W3F1-2008-0059

September 18, 2008

SUBJECT: License Amendment Request NPF-38-279
Relocation of TS 3.7.8 and Addition of LCO 3.0.8 Regarding
the Inoperability of Snubbers
Waterford Steam Electric Station, Unit 3
Docket No. 50-382
License No. NPF-38

FIGURE 4.7-1
SAMPLING PLAN FOR SNUBBER FUNCTIONAL TEST

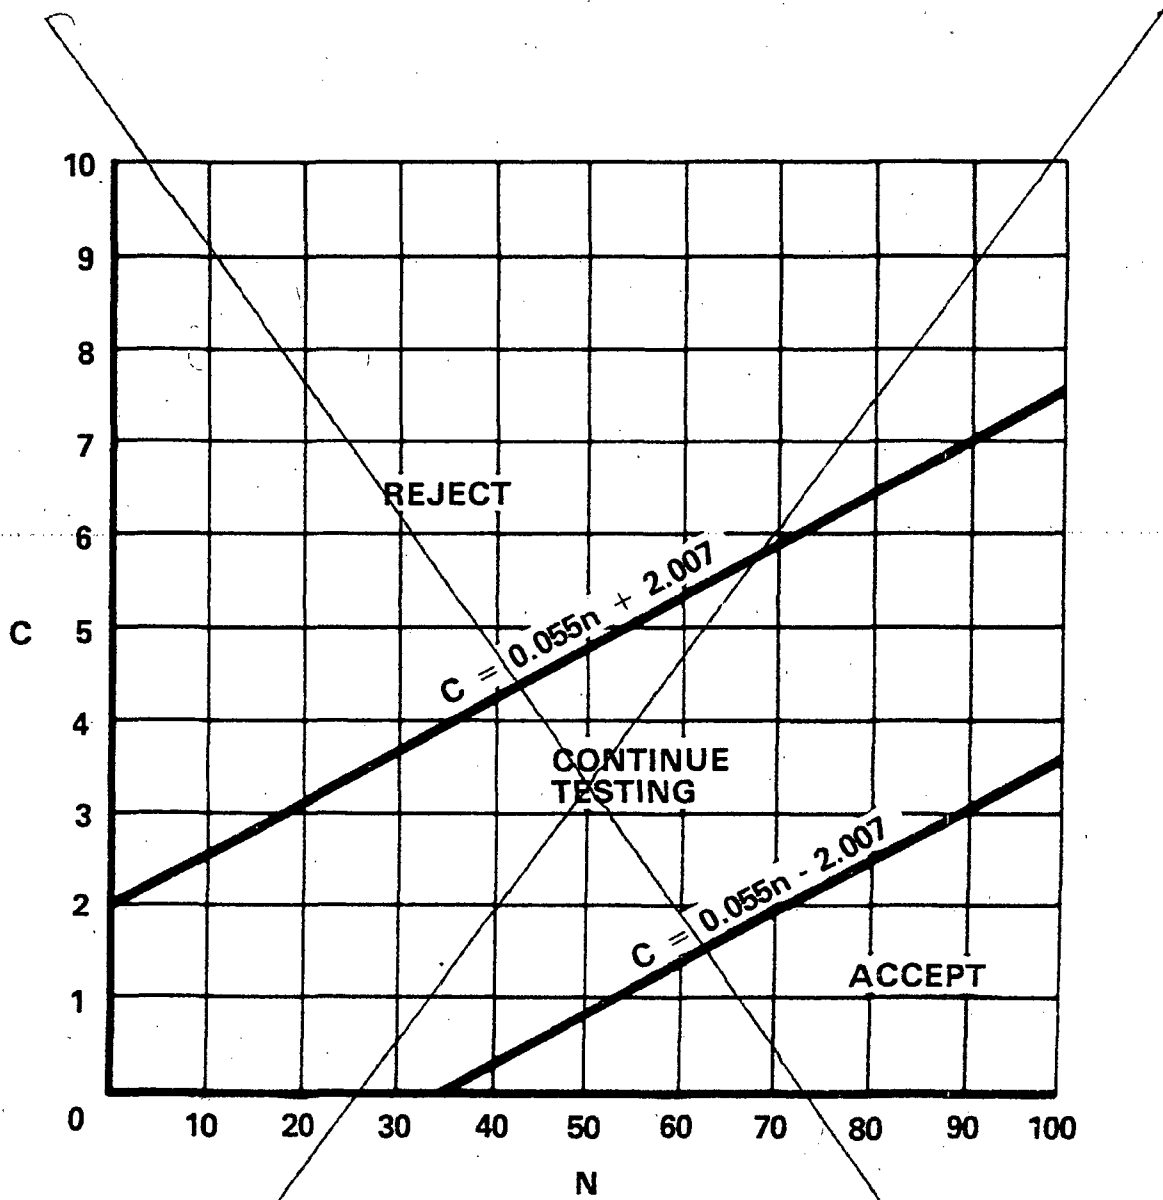
The proposed amendment would modify Waterford Steam Electric Station, Unit 3 (Waterford 3) Technical Specification (TS) requirements for inoperable snubbers by relocating the current TS 3.7.8, Snubbers, to the Technical Requirements Manual (TRM) and adding Limiting Condition for Operation (LCO) 3.0.8. In conjunction with the proposed changes, TS Bases for LCO 3.0.8 will be added, consistent with the Bases Control Program as described in Section 6.16 of the TS.

3/4.7.8 SNUBBERS

3.7.8 All hydraulic and mechanical snubbers shall be OPERABLE.
